Appendix: Previously Reviewed Baseline Upgrade Recommendations for the July 2020 PJM Board Review

Dominion Transmission Zone: Baseline 115kV Line #141 & #28 Rebuild

Existing (b3098) Scope and Cost Modification

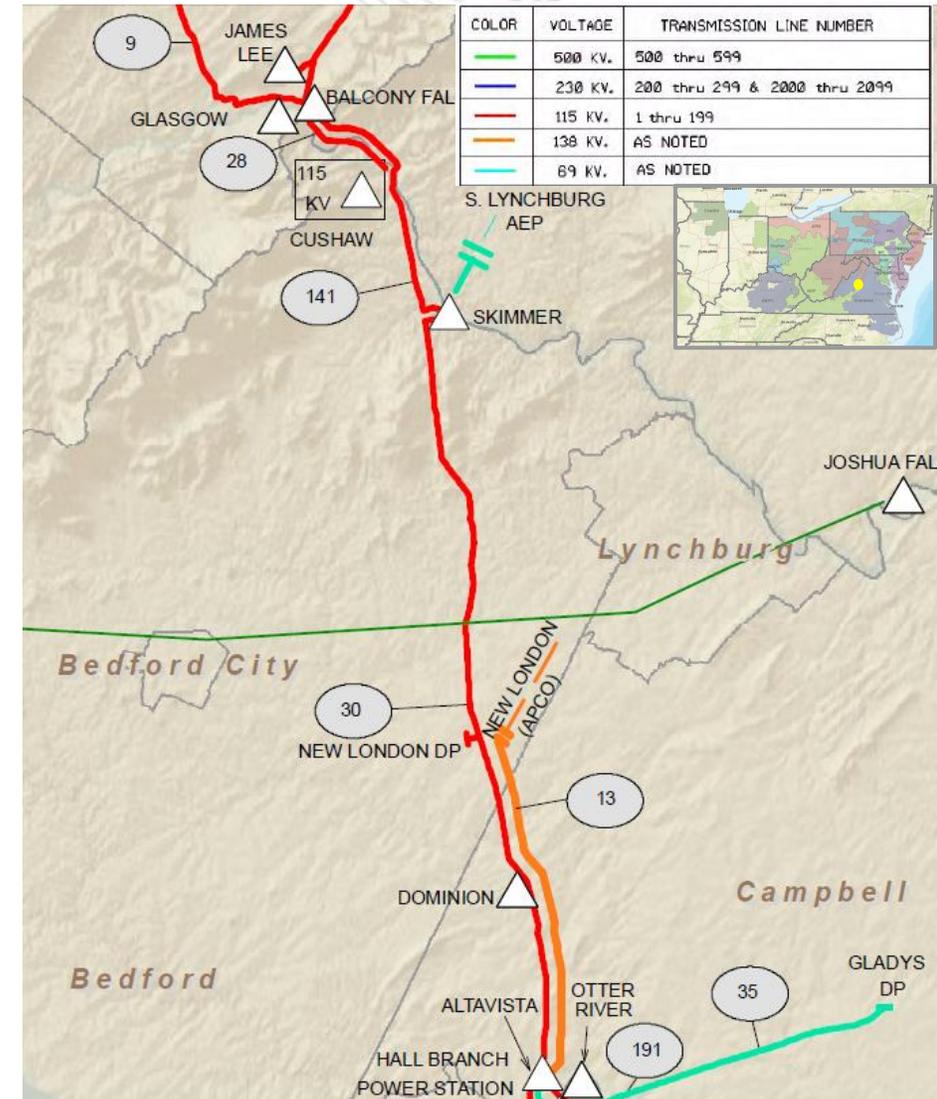
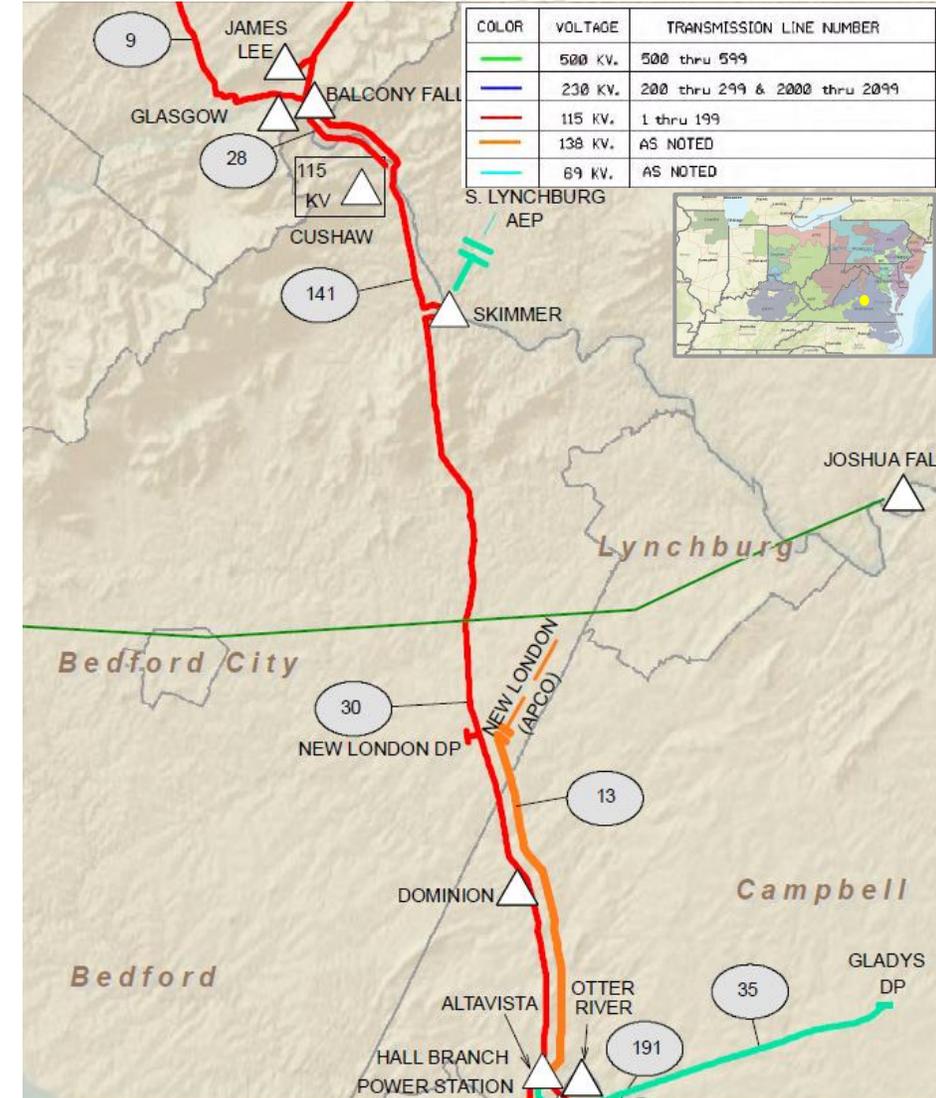
Reason for Cost Increase and Scope Modification:

- a. The Balcony Falls was part of our acquisitions from APL and it appears the lattice structure that all 4 lines and the cross bus terminate on was built in 1926.
- b. Visually it appears that the galvanizing is moderately to severely worn along large portions of the structure. Our structural group does not want to make any changes that would require additional stress be placed on this structure

- **(Same as original solution)** Rebuild the main line #141 and line #28 to current standards. **(Est. cost \$20M)**
- **(New)** Rebuild Balcony Falls Substation **(Est. cost \$9M)**

Additional Scope for Project B3087

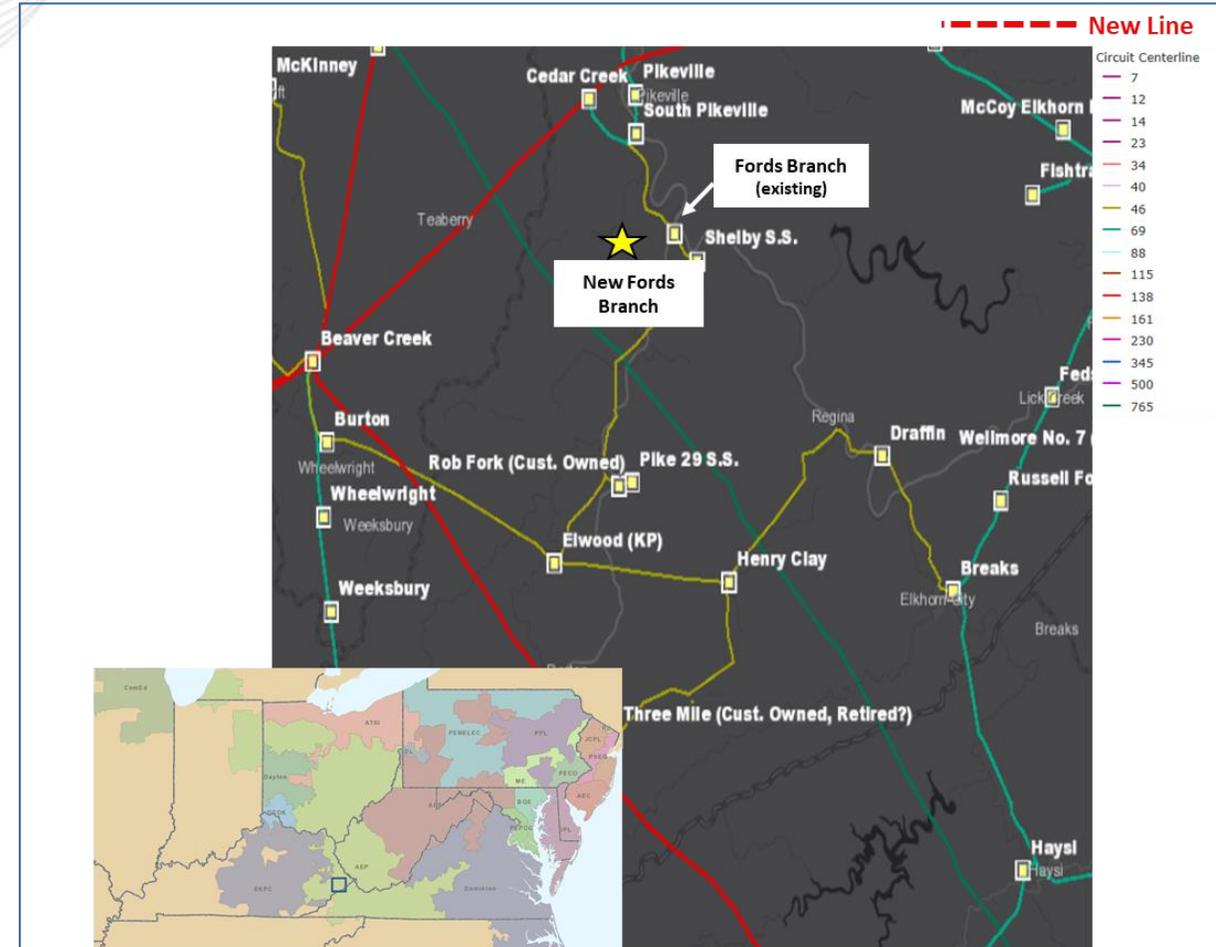
Additional Scope: Install a 28.8MVar switching shunt at the new Fords Branch substation **(B3087.4)**

Reason for the additional scope:

- For the N-1-1 Loss of Beaver Creek Transformer #1 and the loss of Cedar Creek – Johns Creek 138kV line, voltage magnitude violations are identified at New Fords Branch substation (0.90 pu), Cedar Creek 138kV (0.90 pu).
- For the N-1-1 Loss of Beaver Creek – Kewanee (New Fords Branch) 138kV and Cedar Creek – Johns Creek 138kV line, voltage magnitude violations issues are identified at the new Fords Branch substation (0.87 pu), Cedar Creek 138kV (0.87pu), Cedar Creek 69kV (0.90 pu).

Scope Change (B3099)

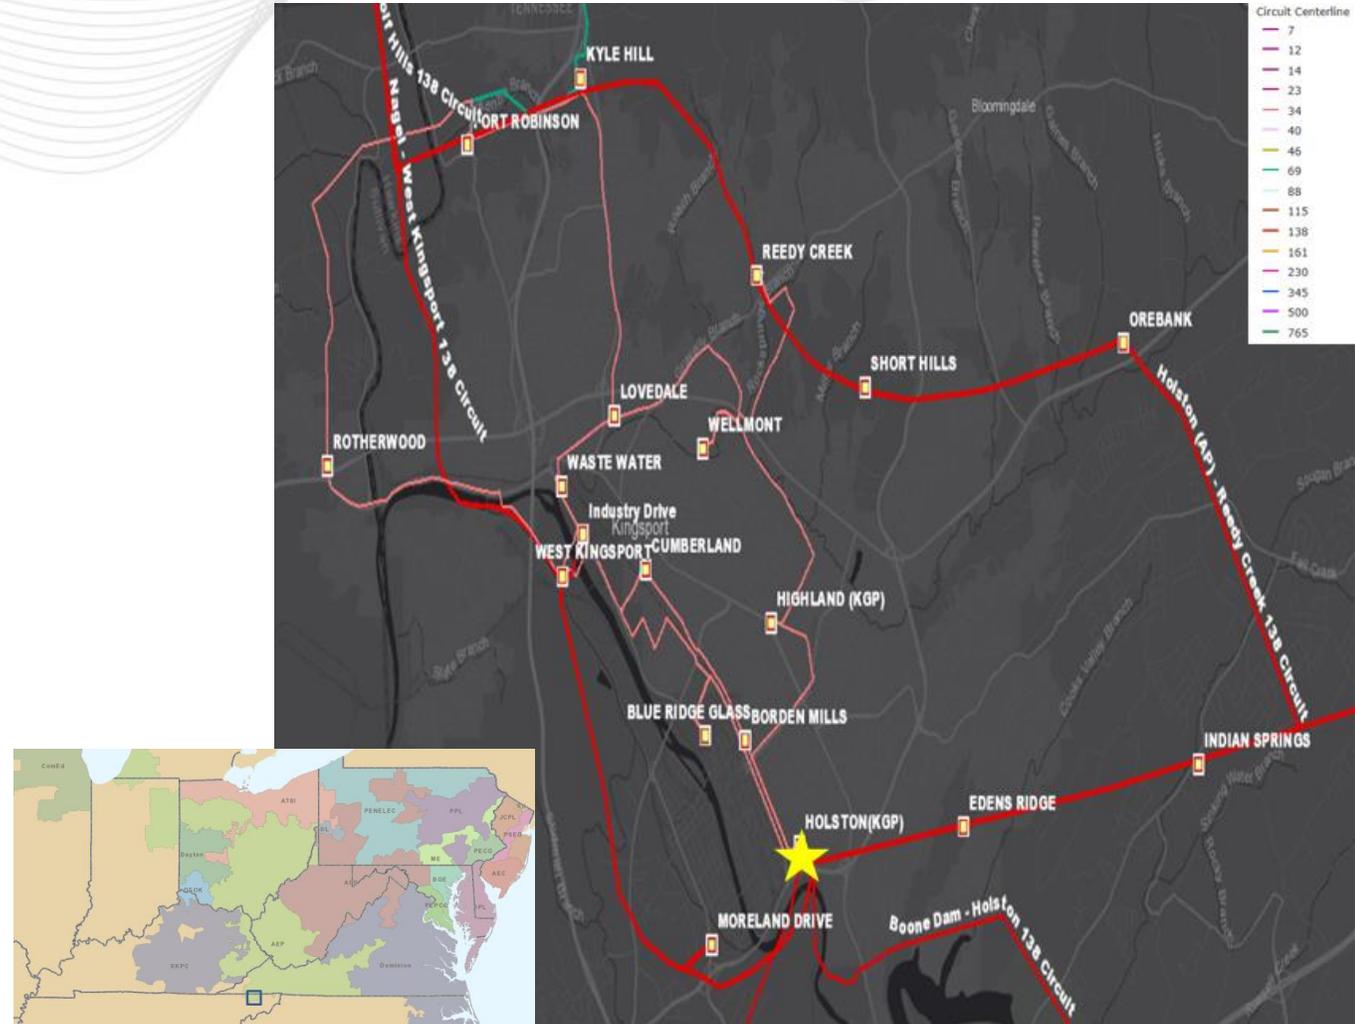
New Scope: Install a 138 kV 3000A 40 kA circuit switcher on the high side of the existing 138/34.5 kV transformer #5 **and a 138 kV 3000A 40 kA circuit switcher transformer #7** at Holston station.

Reason for change: Transformer 7 serves distribution customers but is located in a Transmission station. After investigating the cost responsibility for the switcher installation with Distribution, the cost should be assigned to Transmission.

Required IS Date Change (B2753.9)
Previously Presented: 6/30/2017
7/21/2017SRTEAC

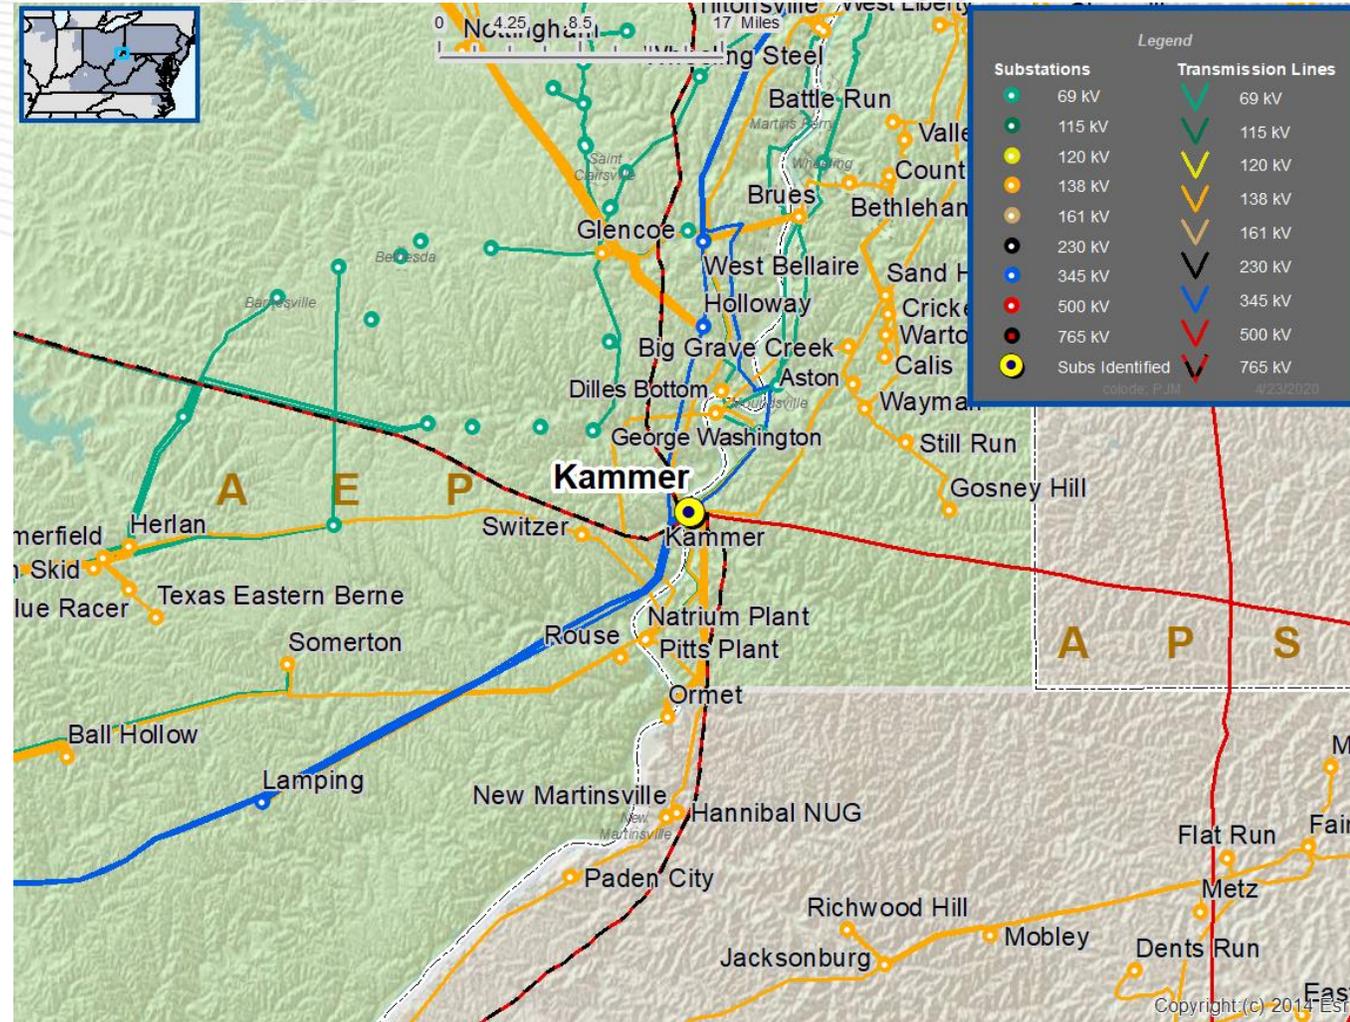
Estimated Cost: \$0M
Old Required IS Date: 5/31/2020
New Required IS Date: 9/13/2021

Reasons for the Required IS Date Change:
Opening of Kammer 345-138kV transformer 301 is to address overdutied breakers at Kammer 138kV. Due to the withdrawn queue of Y3-068, re-studied shows the breakers are overduty only after AB2-093, whose IS date is 9/13/2021.
